SUBJECT: ROCKWELL HANFORD OPERATIONS DOCUMENT SD-BWI-TI-109,  
"... HYDRAULIC TESTING OF MIDDLE SENTINEL BLUFFS..."

WASTE MANAGEMENT DOCUMENT REVIEW

DOCUMENT: Preliminary Results of Hydraulic Testing of the Middle Sentinel Bluffs Basalt Colonnade/Entablature (3175-3244) feet at Borehole RRL-2, Rockwell Hanford Operations (RHO), SD-BWI-TI-109, released January 1983.

Figure 1. Flowrate vs. transmissivity for each step.  
 T1-109 Cohasset Interior  
 4 Step Injection Test

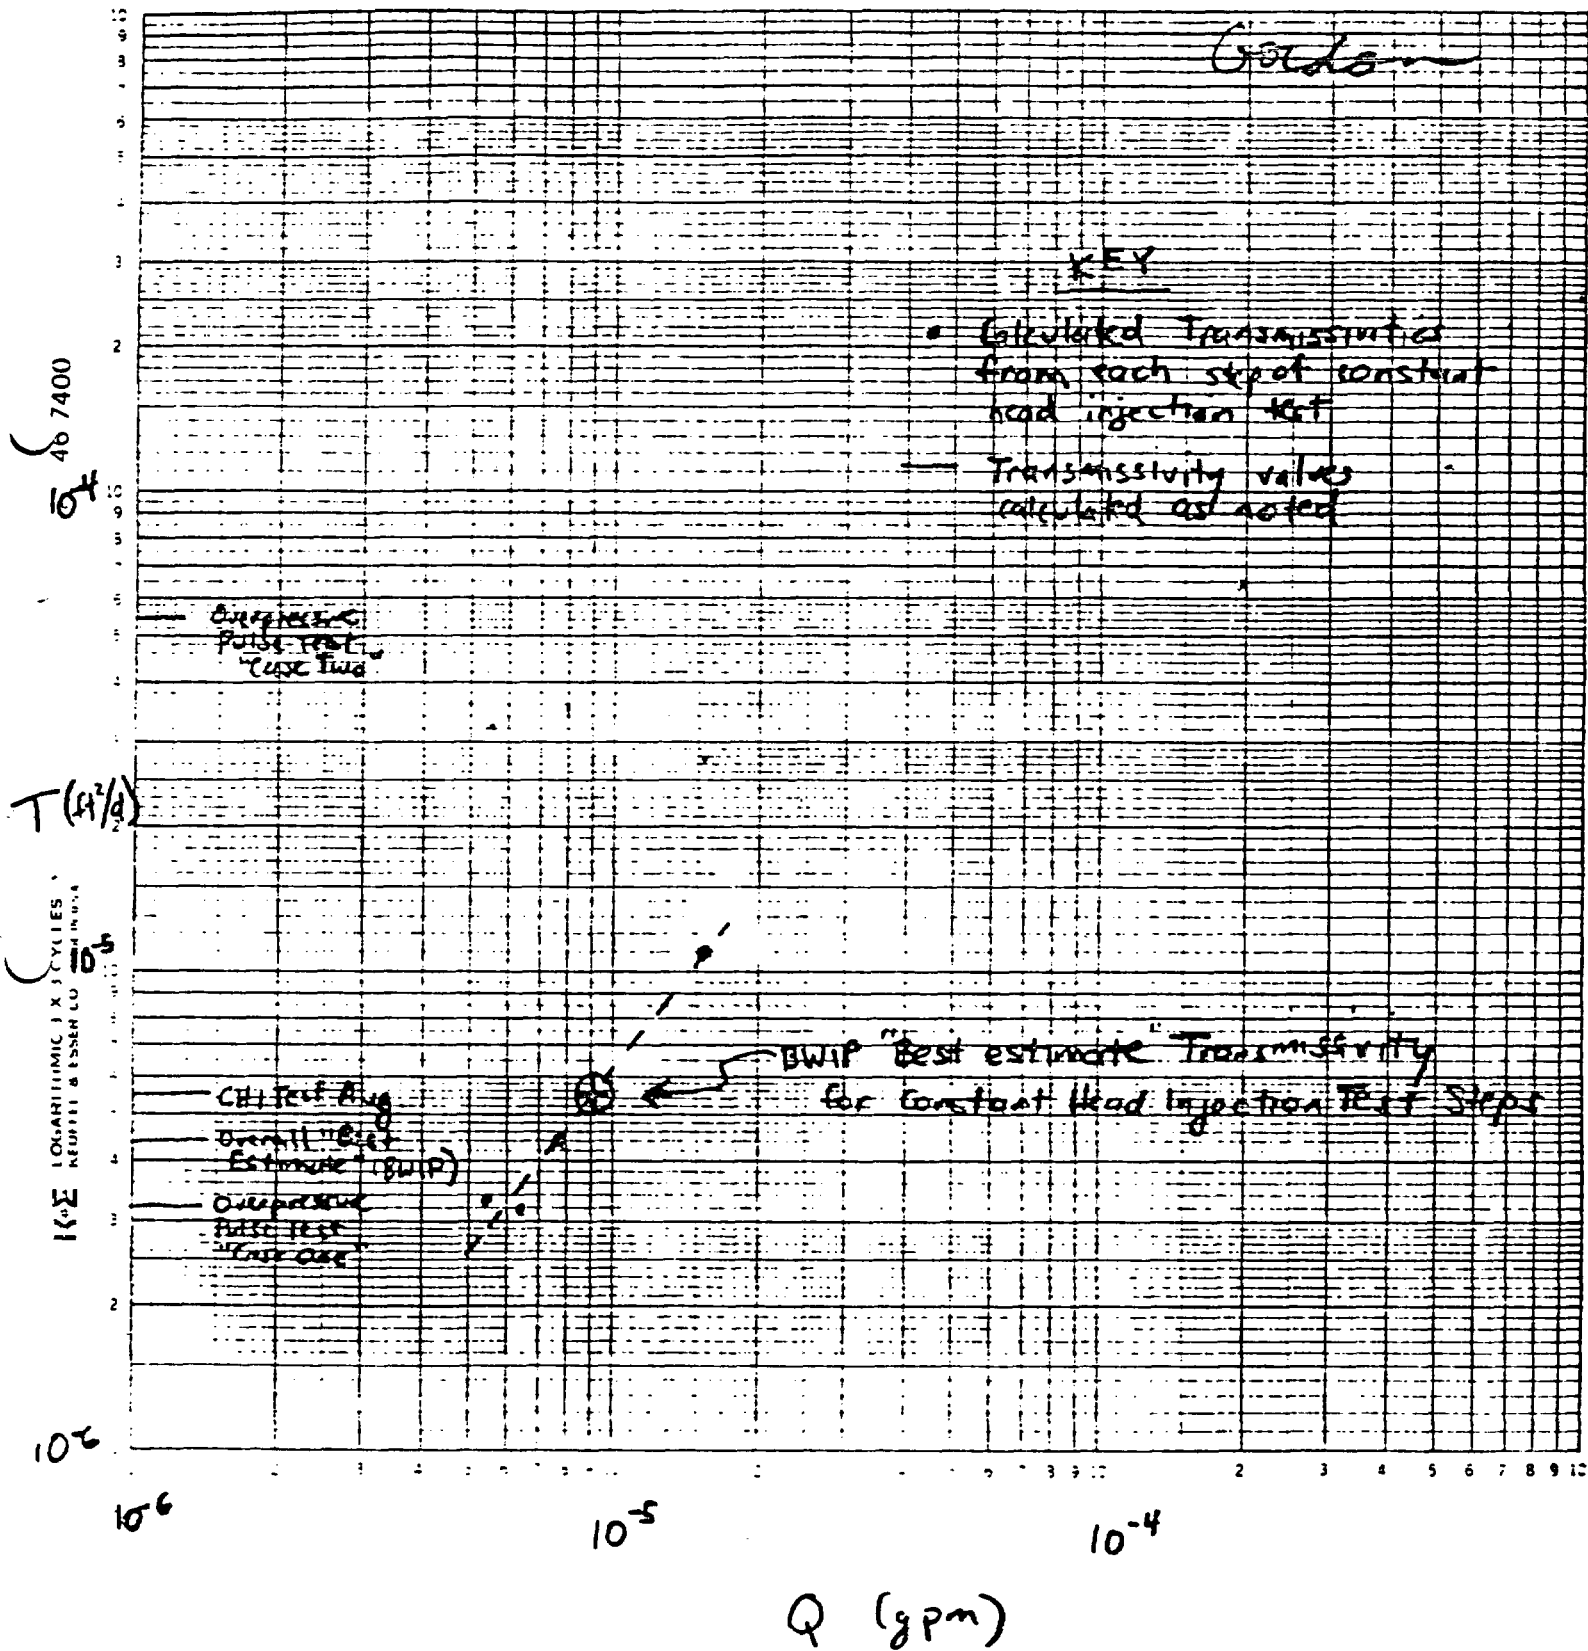
- 1) BWIP has ignored the fact that the responses to the four steps of the described constant head injection test are inconsistent with theoretical responses. This inconsistency calls the constant head injection test results into question.
- 2) BWIP chose an average, rather than a conservative value for their "best estimate" of constant head injection test results.
- 3) The described overpressure pulse test appears to have been analyzed in two ways: one contrary to existing literature on the subject (yielding a low value of transmissivity) and the second consistent with existing literature on the subject (yielding a transmissivity value an order of magnitude higher). The results of the second (correct, based on existing literature) analysis were thrown out, apparently because the yielded transmissivity was higher than expected.
- 4) No storativity values were reported.

BWIP does not indicate the temperature of injected fluid; this could make their estimates of imposed heads erroneous, as NRC has pointed out in reference to other tests at BWIP (c.f., Wright to Olson, May 25, 1984). Regardless of this point, however, the results presented by BWIP in Table 2 of the subject report (attached) indicate substantial irregularities in these tests. Figure 1 shows the calculated transmissivities as a function of the steady-state flow rates for each step. These should theoretically plot along a straight horizontal line. Figure 2 shows the steady flow rate as a function of the imposed head. This should plot as a straight line of positive slope with flow (Q)=0 intercept at imposed head (H)=0. However, this is not the case for the BWIP tests. For example, the BWIP tests indicate that the lowest head imposition required the highest flow rate to maintain, which is contrary to the theoretical response. The only portion of the plot which even has positive slope is section B; however, this section has a Q-intercept (H=0) at  $-1.56e-5$  gpm, rather than zero.
